# RENESAS TECHNICAL UPDATE

Product Category	MPU & MCU		Document No.	TN-RX*-A102A/E	Rev.	1.00
Title	Corrections to Manual regarding the USB 2.0 Host/Function Module (USB) in the RX62N Group and RX621 Group		Information Category	Technical Notification		
Applicable Product	RX62N Group, RX621 Group	Lot No.	Reference Document	RX62N Group, RX621 Group User's Manual: Hardware Rev.1.30 (R01UH0033EJ0130)		
		All

This document describes corrections to section 28, USB 2.0 Host/Function Module (USB) in RX62N Group, RX621 Group User's Manual: Hardware.

Figure 28.11 Timing of BRDY Interrupt Generation (When Function Controller Function is Selected)

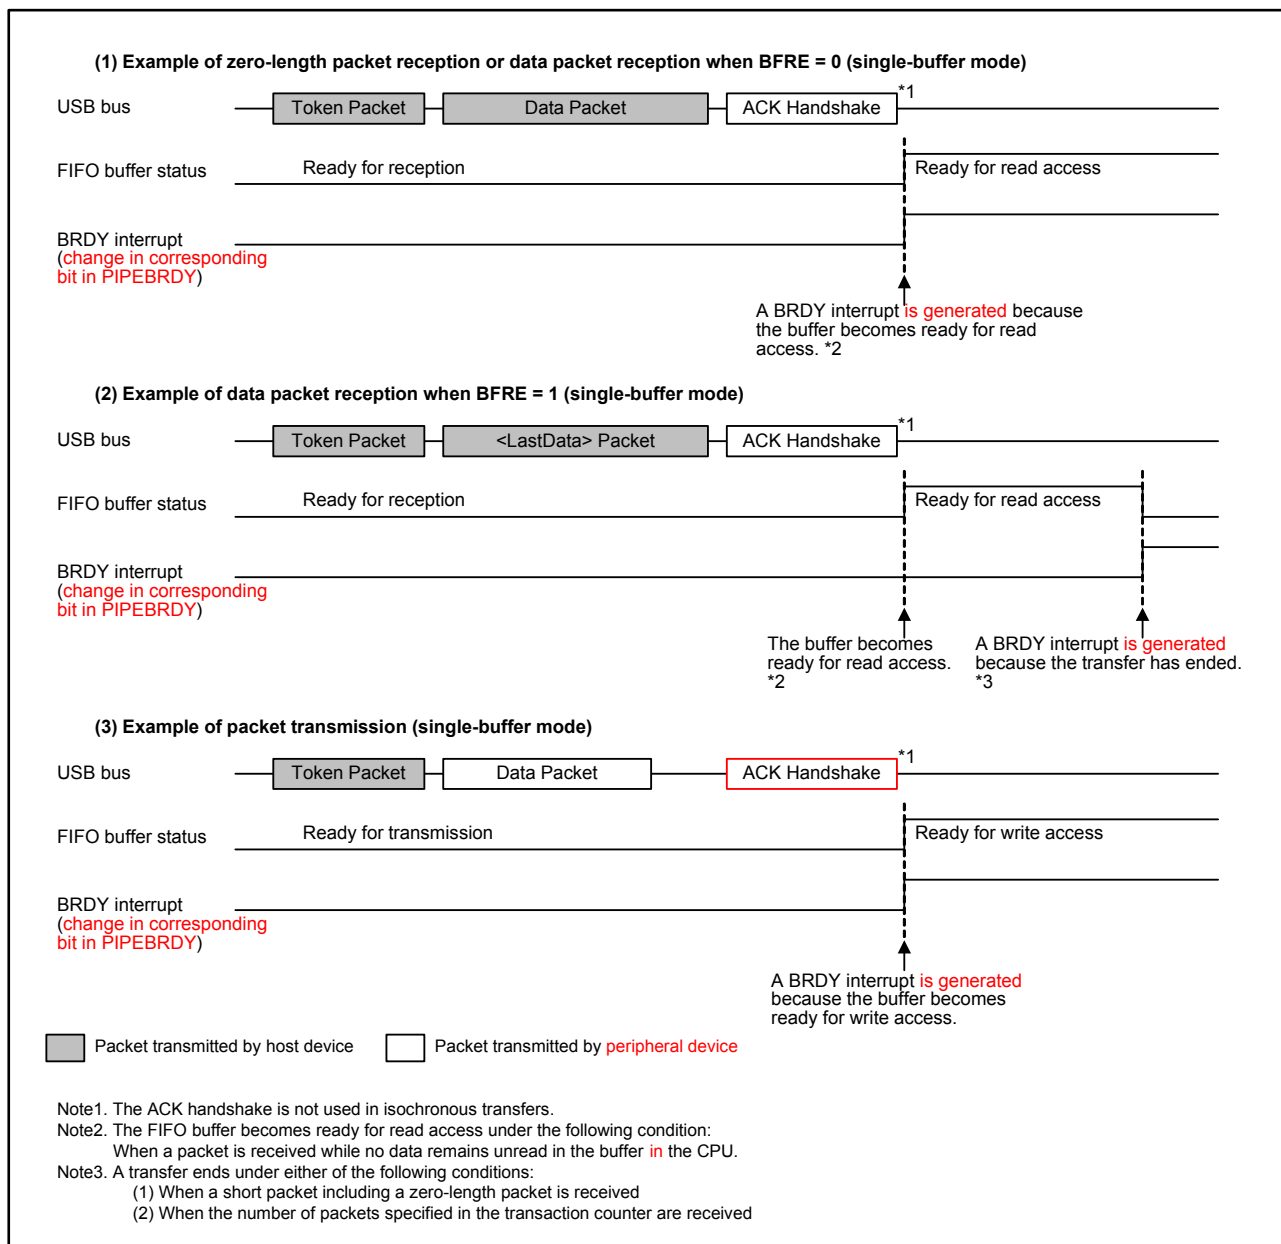
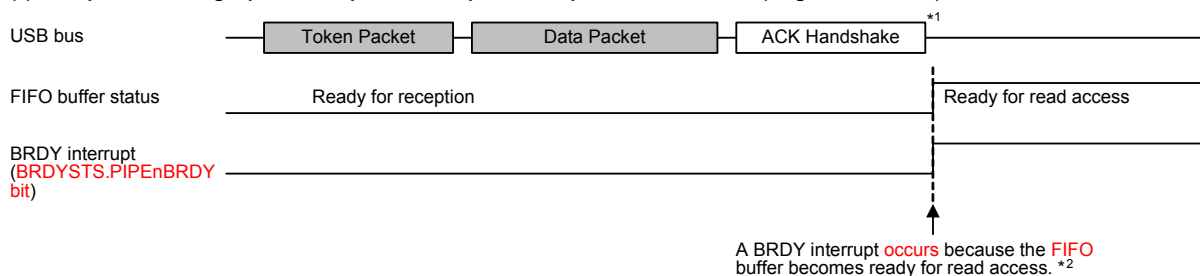
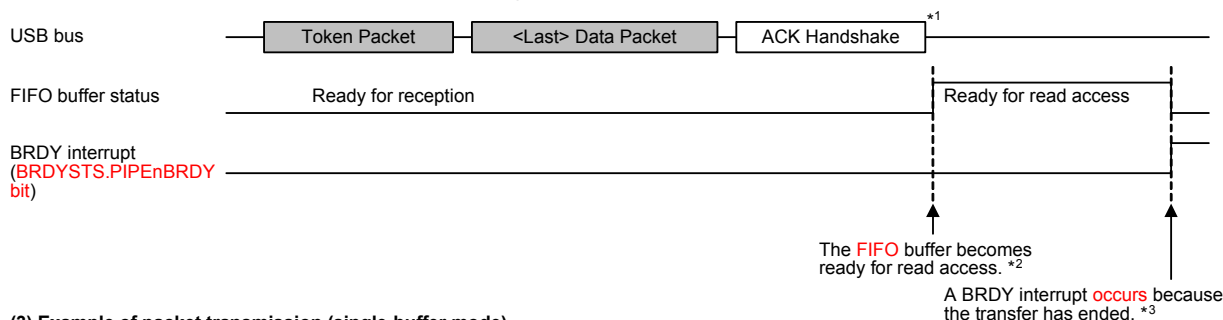
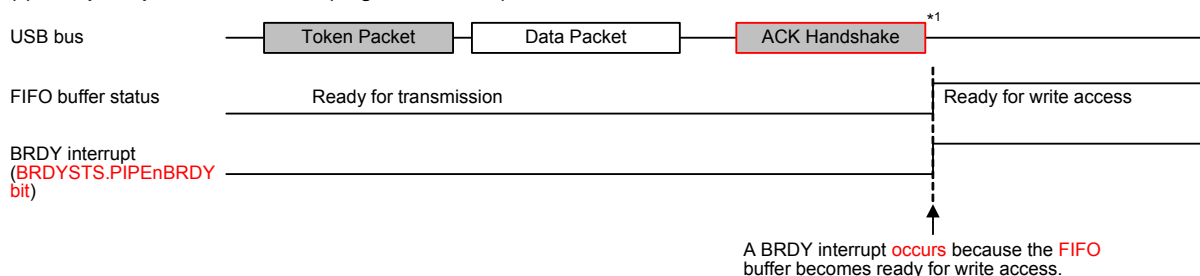
Figure 28.11 is corrected as follows:

## (1) Example of zero-length packet reception or data packet reception when BFRE = 0 (single-buffer mode)

## (2) Example of data packet reception when BFRE = 1 (single-buffer mode)

## (3) Example of packet transmission (single-buffer mode)

Note1. The ACK handshake is not used in isochronous transfers.

Note2. The FIFO buffer becomes ready for read access under the following condition:

When a packet is received while no data remains unread in the FIFO buffer on the CPU side.

Note3. A transfer ends under either of the following conditions:

- (1) When a short packet including a zero-length packet is received
- (2) When the number of packets specified in the transaction counter are received

**Figure 28.12 Timing of NRDY Interrupt Generation (When Function Controller Function is Selected)**

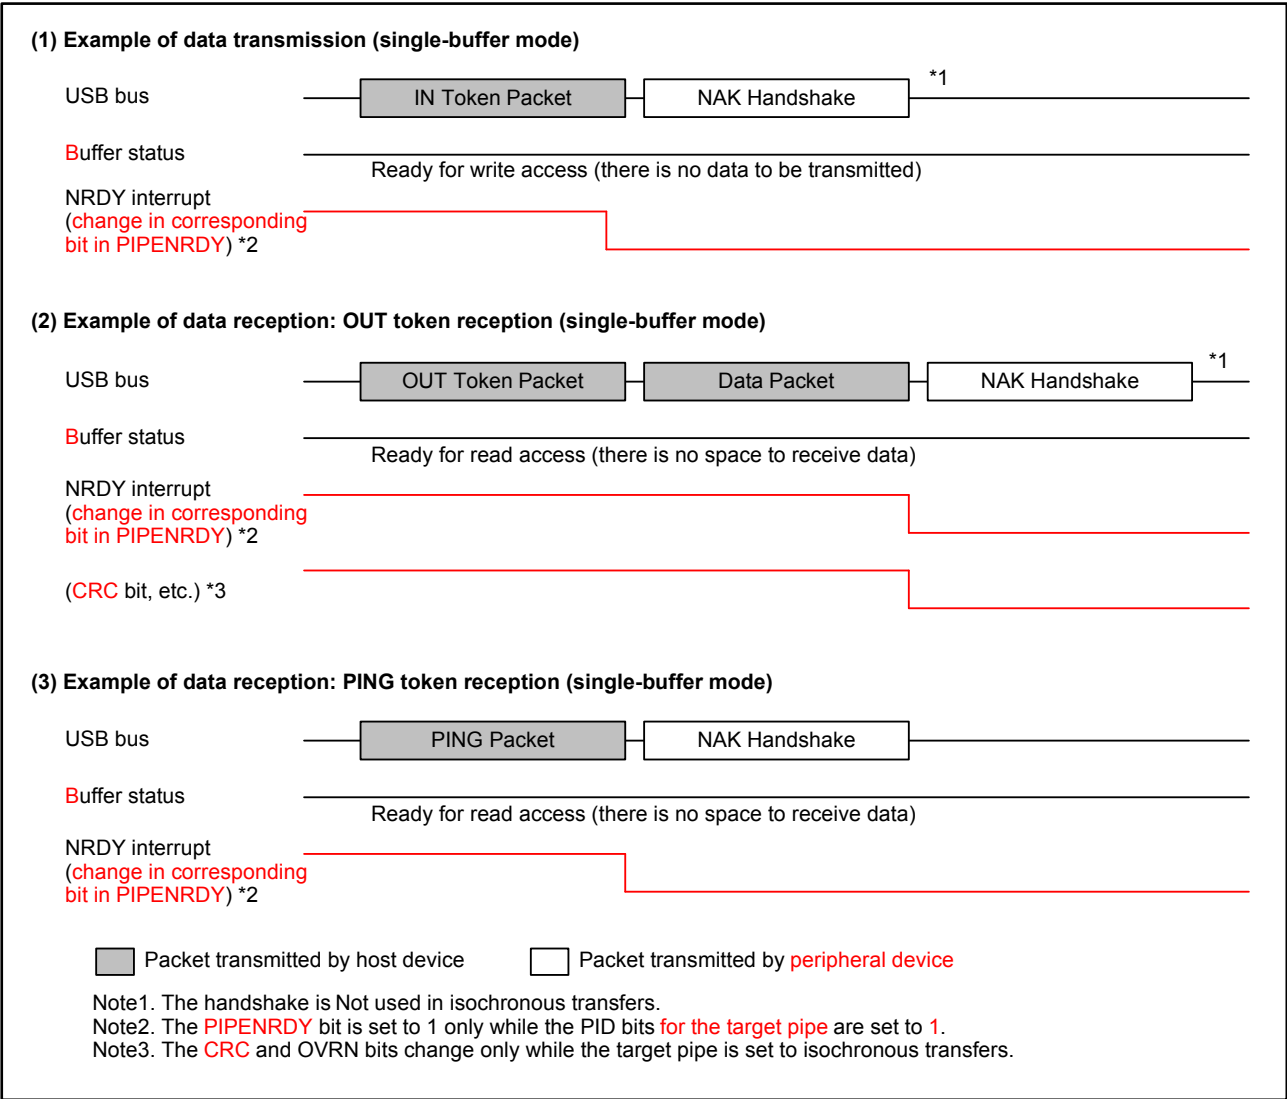
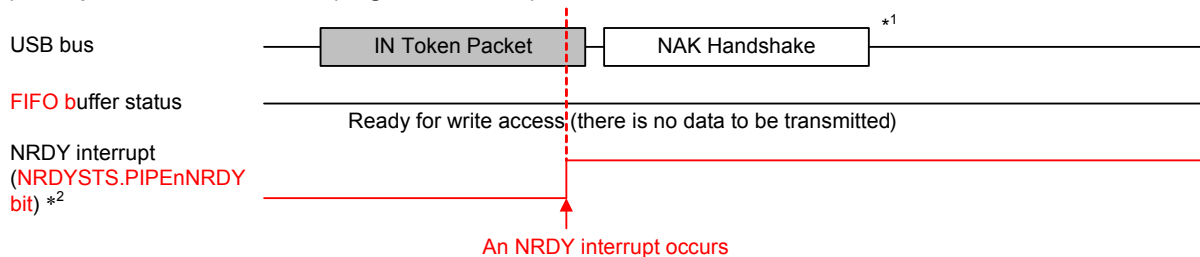
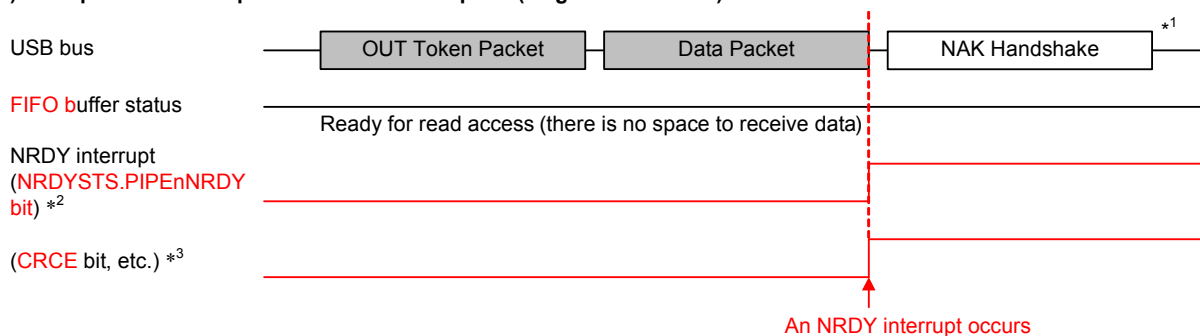
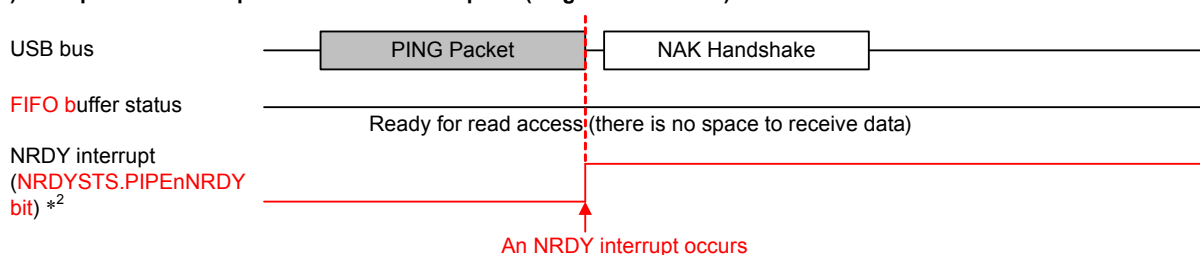
Figure 28.12 is corrected as follows:

## (1) Example of data transmission (single-buffer mode)

## (2) Example of data reception: OUT token reception (single-buffer mode)

## (3) Example of data reception: PING token reception (single-buffer mode)

Note 1. The handshake is Not used in isochronous transfers.

Note 2. The PIPEnNRDY bit is set to 1 only while the PIPEnCTR.PID[1:0] bits are set to 01b (BUF response).

Note 3. The CRCE and the OVRN bits change only while the target pipe is set to isochronous transfers.

**Figure 28.13 Timing of BEMP Interrupt Generation (When Function Controller Function is Selected)**

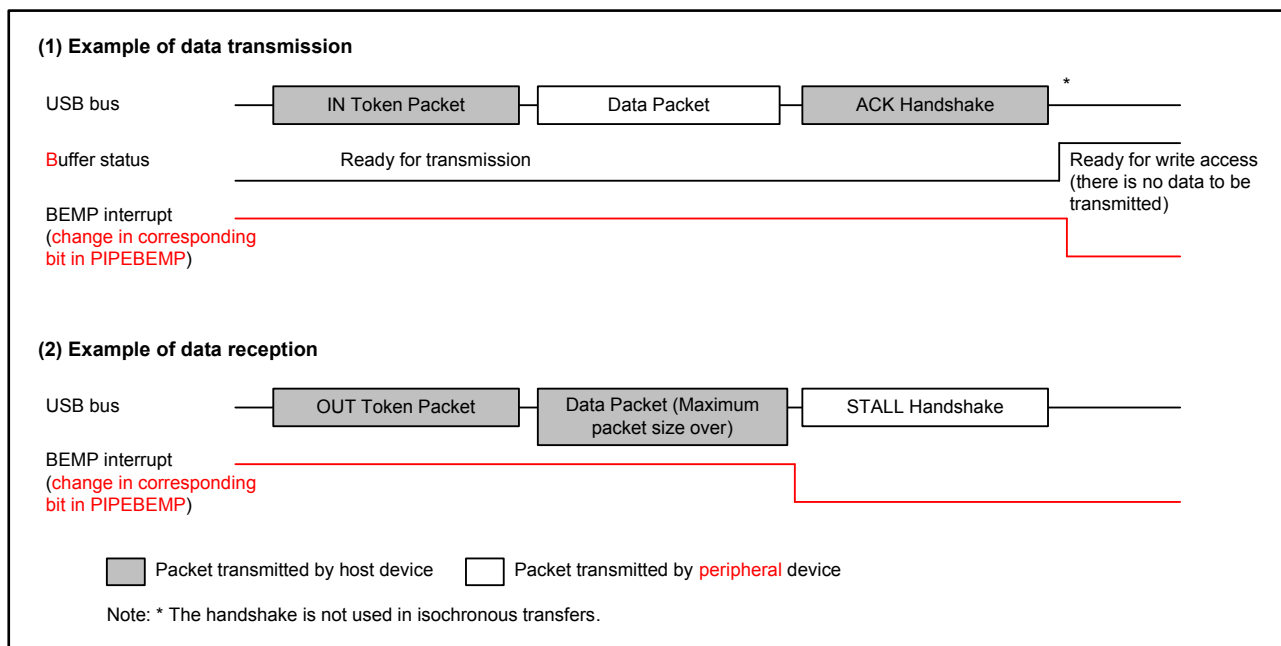
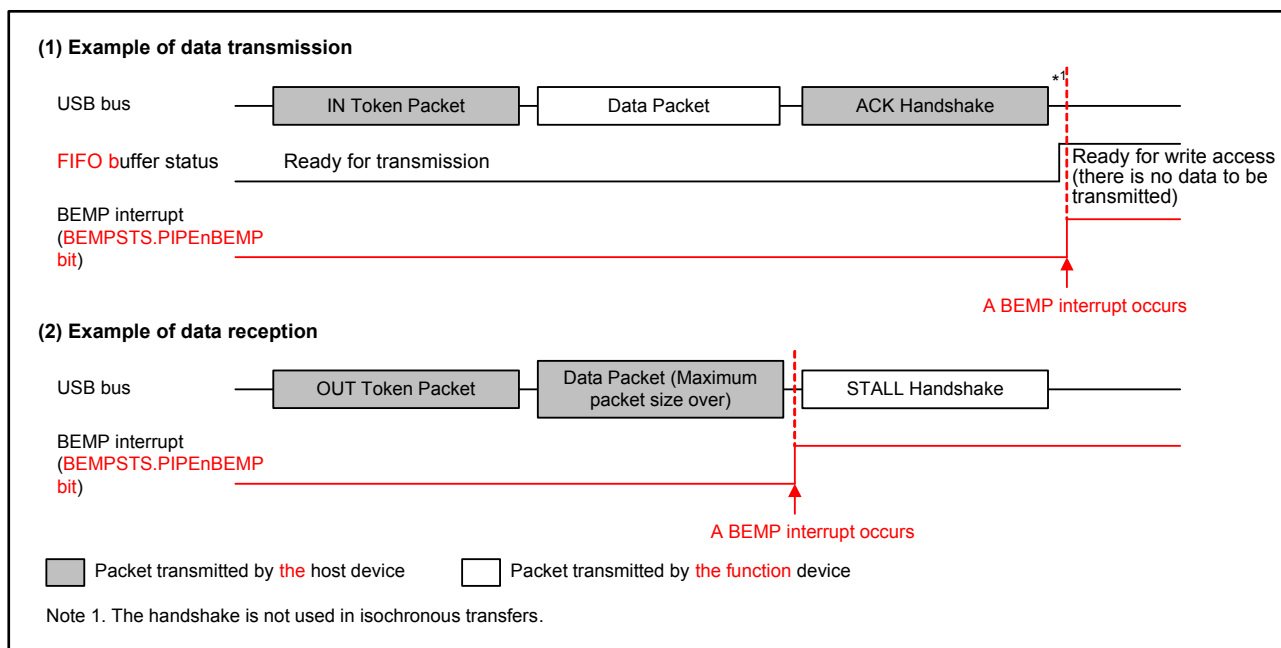
Figure 28.13 is corrected as follows:

Figure 28.18 Relationship between Frames and Expected Token Reception when IITV = 0

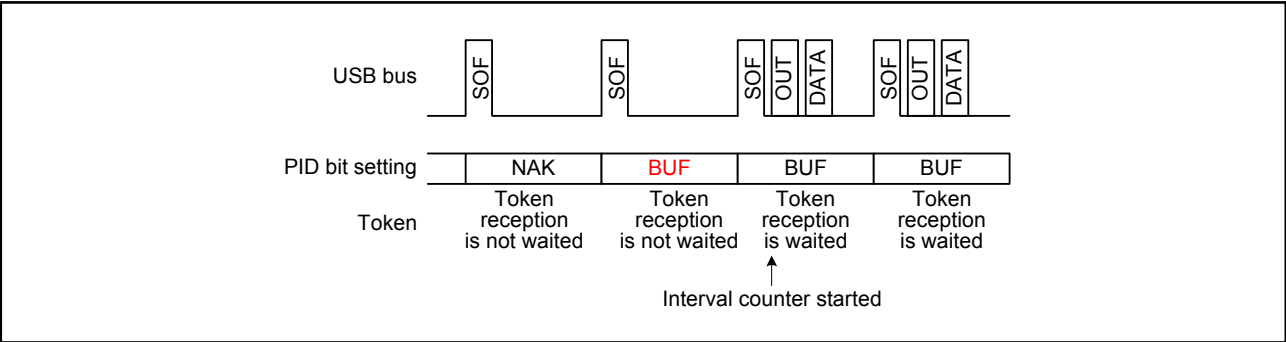
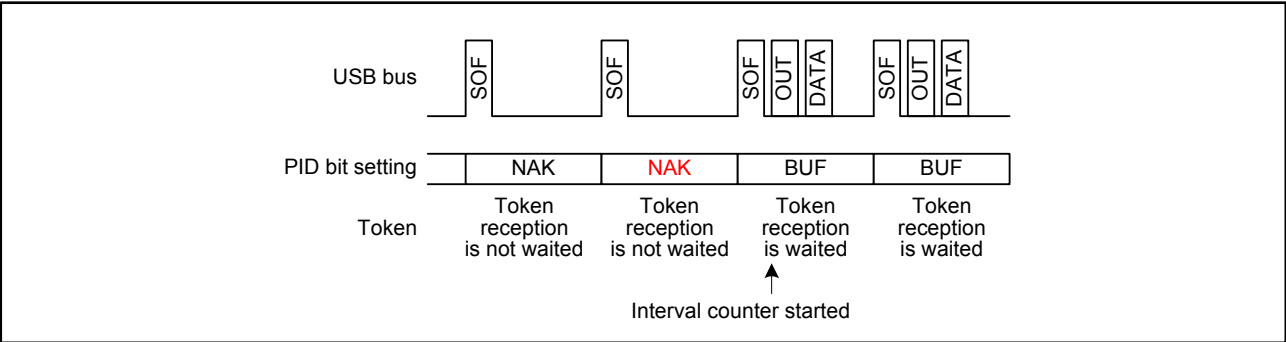
The descriptions for “When IITV = 0” in 28.3.9.3 (3) and Figure 28.18 are corrected as follows:

- When IITV = 0: The interval counting starts at the frame following the frame in which software has set the PID bits for the selected pipe to BUF.

- When IITV = 0  
The interval counter starts when software has set the PID[1:0] bits for the selected pipe to BUF.
